Re: Comments on the draft Desert Renewable Energy Conservation Plan and
EIR/EIS, Docket No. 09-RENEW EO-01

California State Parks comments on the Draft DRECP EIR/EIS

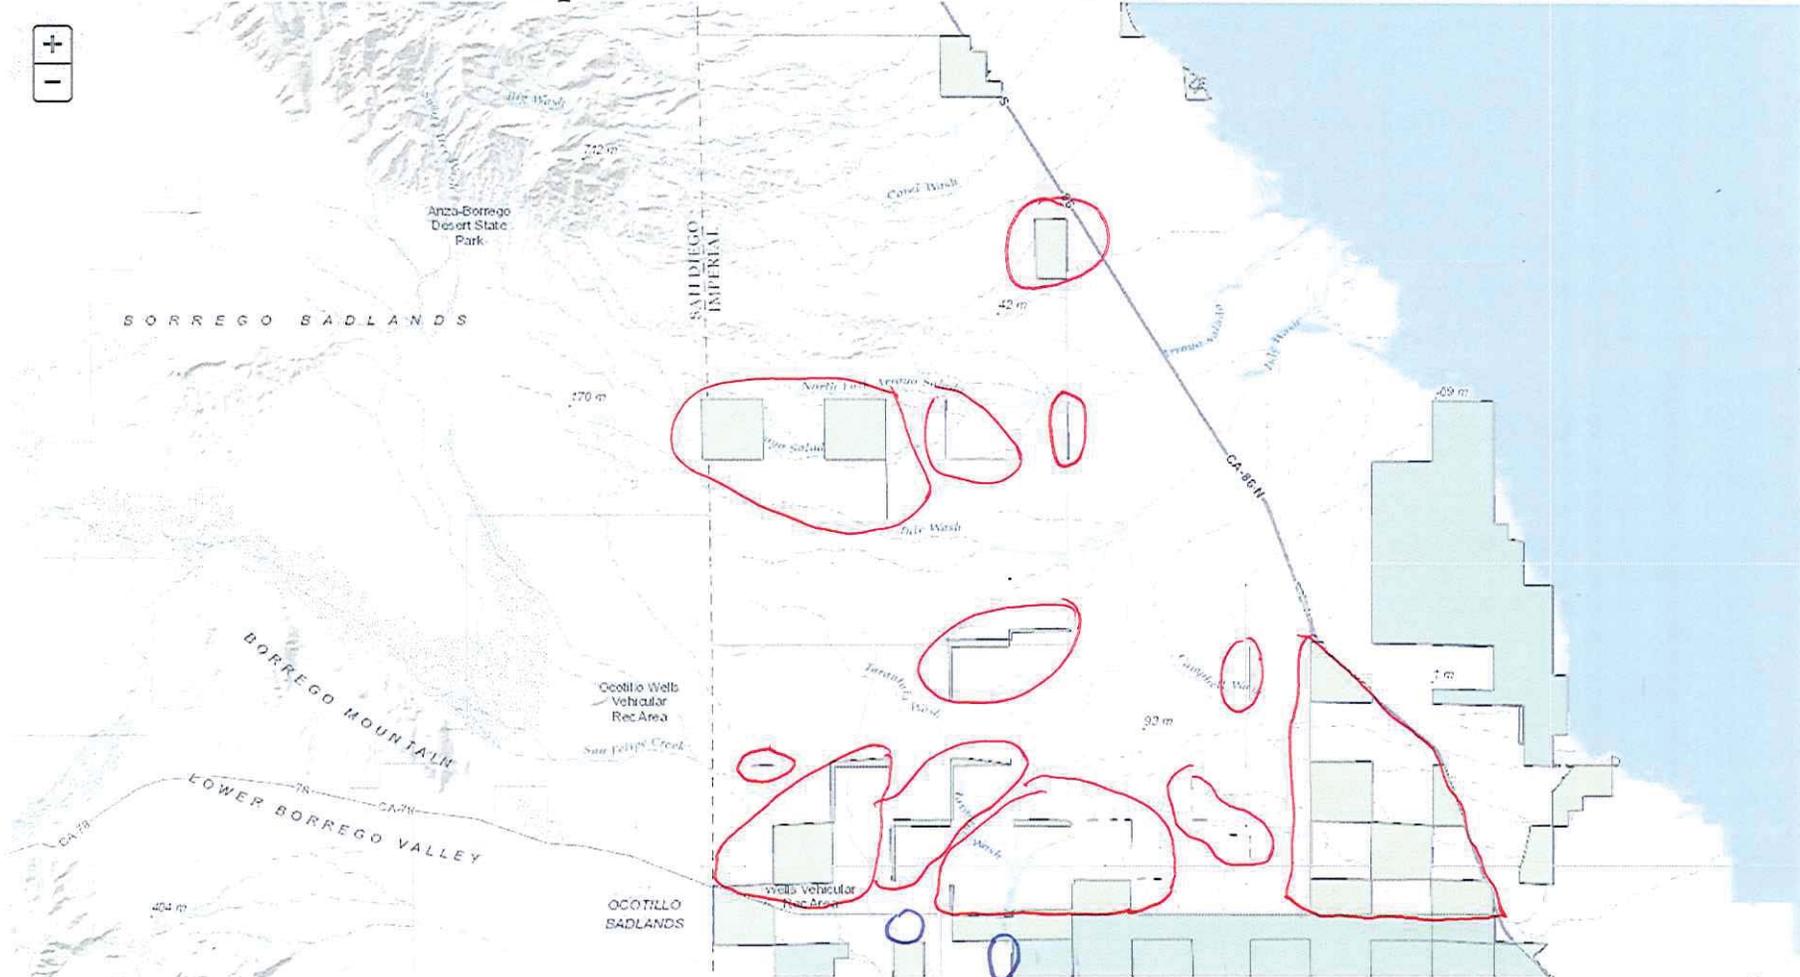
- O Please move mapping errors for ACEC's in OW SURTA - we are in the process of acquiring these properties & they are also designated SRMA & managed under CA State Parks
- O Please ID as highest priority acquisition for mitigation as they provide connectivity between habitat in OW SURTA & BLM ACEC's
